CAMBRIDGE PLACE SUBDIVISION

This is a request for a one-year extension of a previously approved 137-lot subdivision. The subdivision is located on the West side of Eliza Jordan Road North, 3/10 mile ± South of Kelly Road.

APPLICATION NUMBER 6 DATE February 18, 2010

DETAIL SITE PLAN

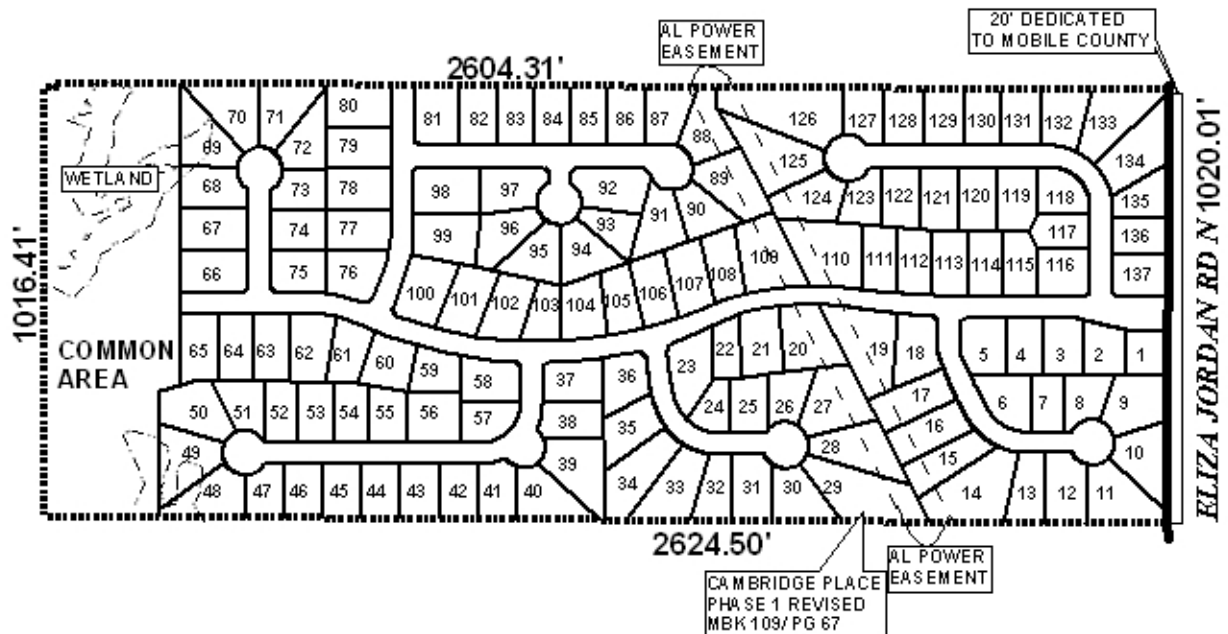
Since the original approval, the Subdivision Regulations were revised, in April 2008, to require a 120' cul-de-sac right-of-way diameter for closed-end streets without center medians, as per the 2003 International Fire Code requirement. Since the subdivision is proposed to have cul-de-sacs without center medians, and road construction is not underway, the cul-de-sacs should be modified to reflect the 120' right-of-way diameter requirement.

Stormwater and flood control were also not addressed in the original approval. While the site is located in the county, compliance with the Mobile County Flood Damage Prevention Ordinance will be required. Development shall be designed to comply with the storm water detention and drainage facility requirements of the City of Mobile storm water and flood control ordinances, and requiring submission of certification from a licensed engineer certifying that the design complies with the storm water detention and drainage facility requirements of the City of Mobile storm water and flood control ordinances prior to the issuance of any permits. New public roads shall be constructed and paved to standards for County Maintenance, and accepted by Mobile County, while new private roads shall be constructed and paved to minimum County or Subdivision Regulation standards, whichever are greater.

- 1) the subdivision needs to be revised to the current Subdivision Regulations which will require lot reconfigurations;
- 2) the subdivision needs to be revised to meet current stormwater management standards; and
- 3) it has been five years since the last phase was recorded.
